Device TC23x
Marking/Step ES-AC, AC
Package see Data Sheet

10210AERRA

This Errata Sheet describes the deviations from the current user documentation.

Figure 3 Message RAM Configurations

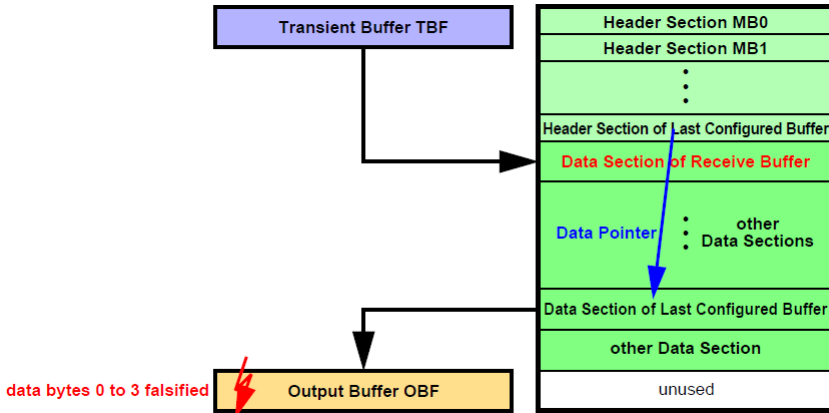
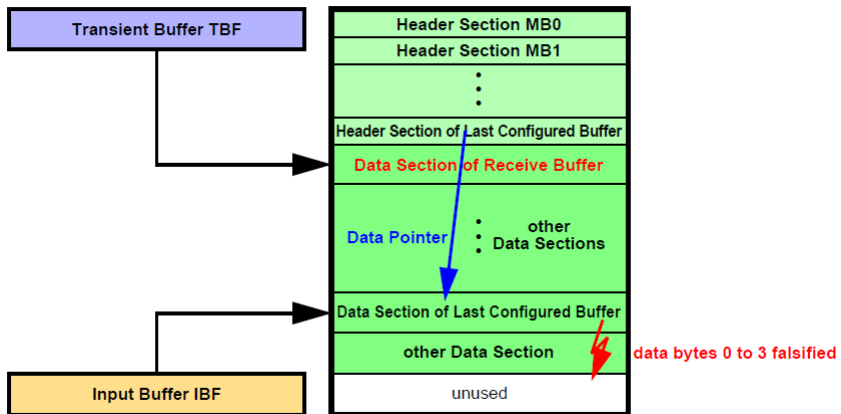
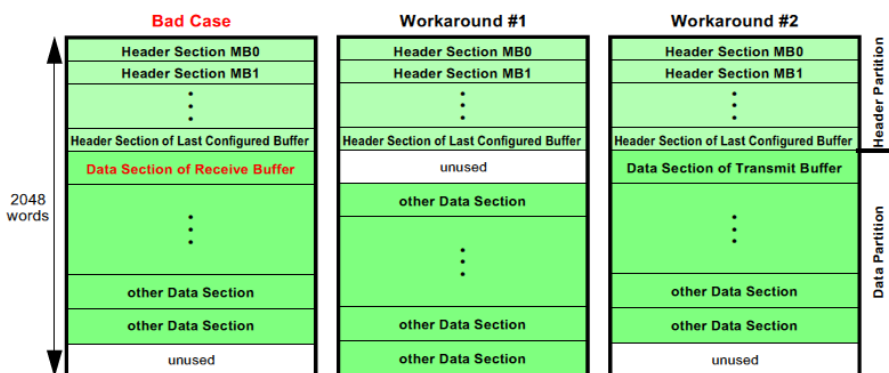
When the message buffer has its payload configured to maximum length (PLC = 127), the OBF word on address 00h (payload data bytes 0 to 3) is overwritten with unexpected data at the end of the transfer.

After the Data Section of the selected message buffer in the Message RAM has been written, one additional write access overwrites the following word in the Message RAM which might be the first word of the next Data Section.

- a) When a message is transferred from the Last Configured Buffer in the Message RAM to the OBF and **PLC** = 127 it may happen, that at the end of the transfer the OBF word on address 00h (payload data bytes 0 to 3) is overwritten with unexpected data (see [Figure 1](#)).
- b) When a message is transferred from IBF to the Last Configured Buffer in the Message RAM, it may happen, that at the end of the transfer of the Data Section one additional write access overwrites the following word, which may be the first word of another message's Data Section in the Message RAM (see [Figure 2](#)).

2) Ensure that the Data Section directly following the Header Partition is assigned to a transmit buffer.

Figure 5 Transmitter - loosing CAN FD node

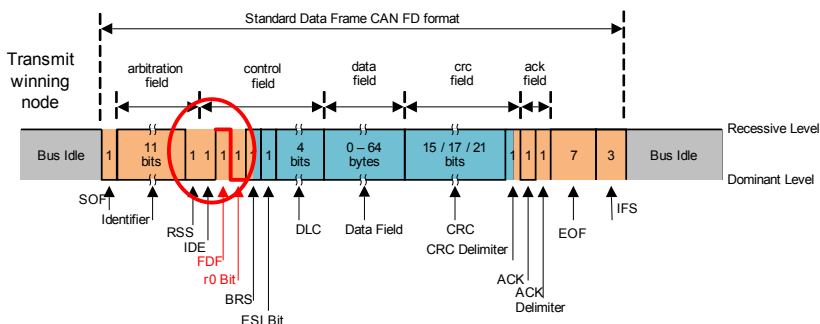
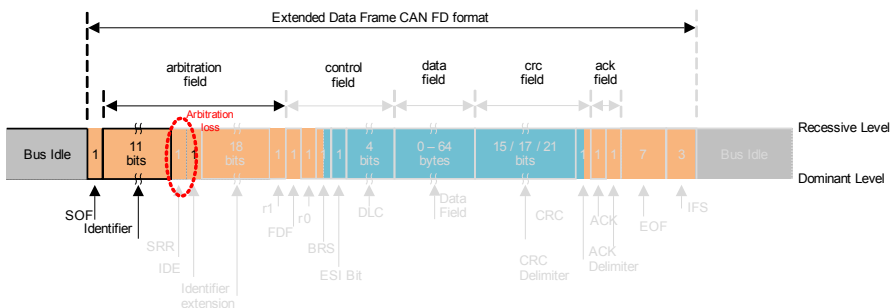
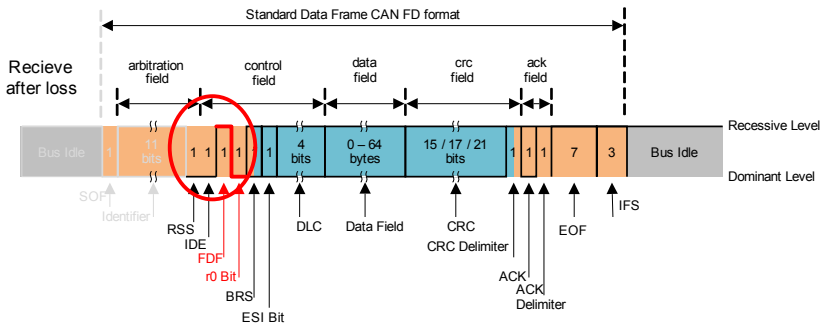
If a transmitter is losing arbitration late (e.g. in an extended frame - see [Figure 4](#) the node which wins arbitration and [Figure 5](#) the transmitting node loosing arbitration), then the FDF bit to res bit is the last chance to synchronize to the

winning node (here as a receiver [Figure 6](#) the same node as in [Figure 5](#)). A timing offset will occur between the now receiving node and the actual transmitter.

The device is producing more error frames within a network than a device with a hardsync at the FDF bit.

Figure 12 Ripple Voltage vs. Frequency Characteristic

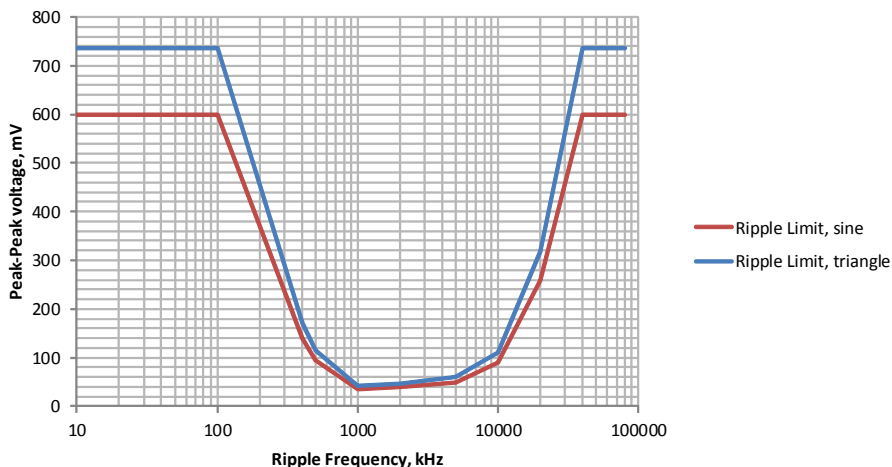
The internal back-up clock is sensitive to specific power supply voltage disturbance/ripple caused by a voltage ripple intrinsic to DC-DC converters. Specific conditions such as insufficient filtering of the ripple may lead to improper behavior of the start-up scheme of the back-up clock, and thus stuck-at state during the start-up of the microcontroller until this condition is removed.

The diagram reflects acceptable ripple level during the cold start of the microcontroller at the respective VDDP3/VEXT/VEVRSB supply of the PMS subsystem, depending on the device and package type, as shown in the following table.

Figure 13 Short Serial Message, Serial Data Encoding over 16 messages

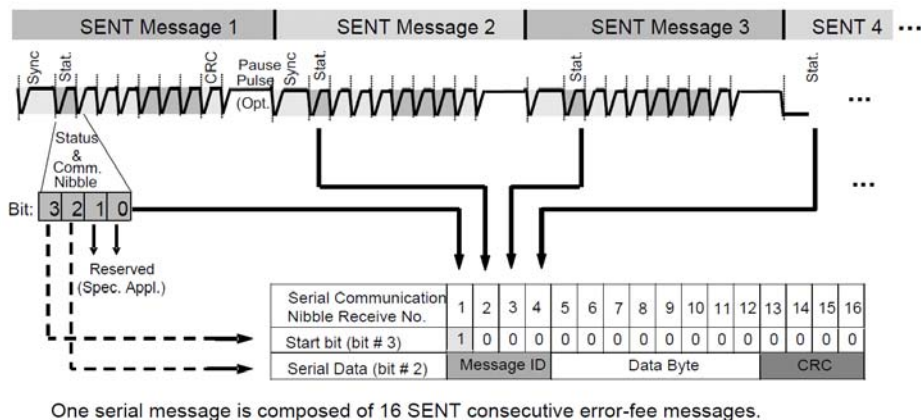
Correction

Figure 13 shows a corrected version of this figure.
